6.0 ADMINISTRATIVE CONTROLS

FIGURE 6.2.1
SOUTH CAROLINA ELECTRIC AND GAS COMPANY
VIRGIL C. SUMMER NUCLEAR STATION
OFFSITE ORGANIZATION

FIGURE 6.2-2
VIRGIL C. SUMMER NUCLEAR STATION
FUNCTIONAL ORGANIZATION

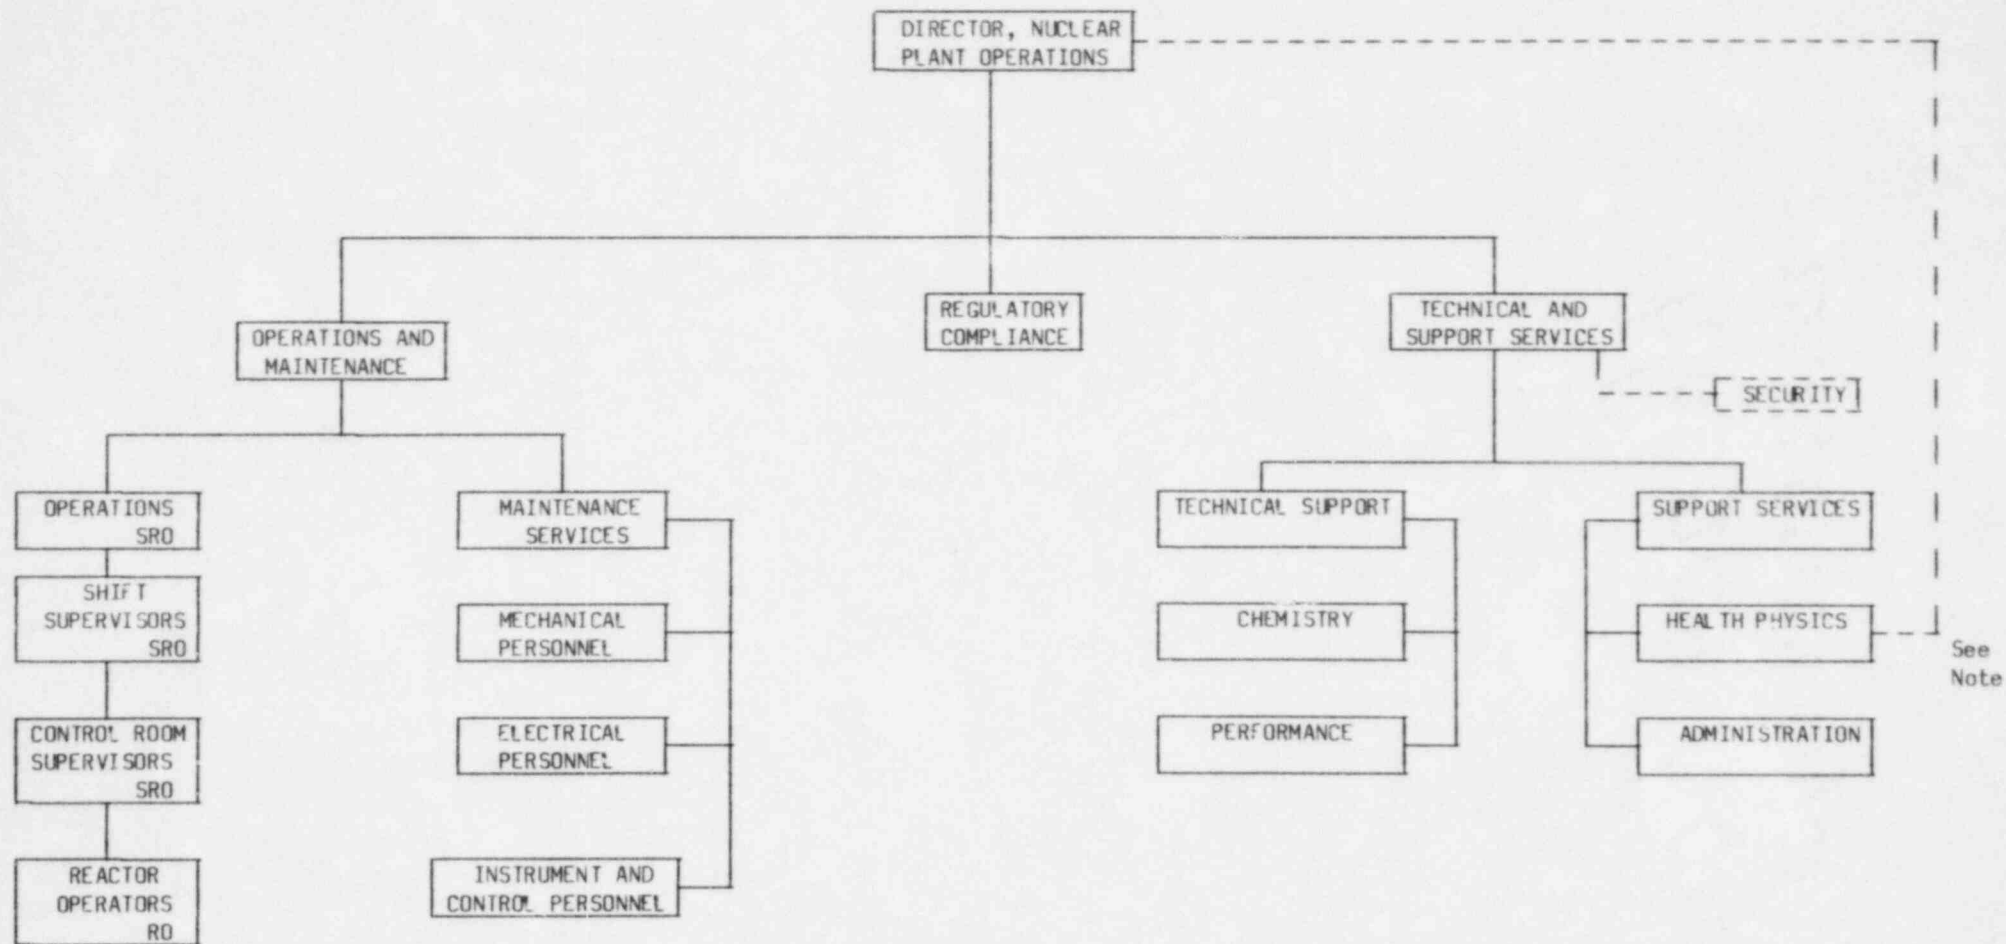
NOTE: Health Physics supervision has direct access to the Director, Nuclear Plant Operations in matters concerning any phase of radiological protection.

NOTE: The title Director, Nuclear Plant Operations is synonymous with the title Manager, Virgil C. Summer Nuclear Station, Station Manager or Plant Manager.
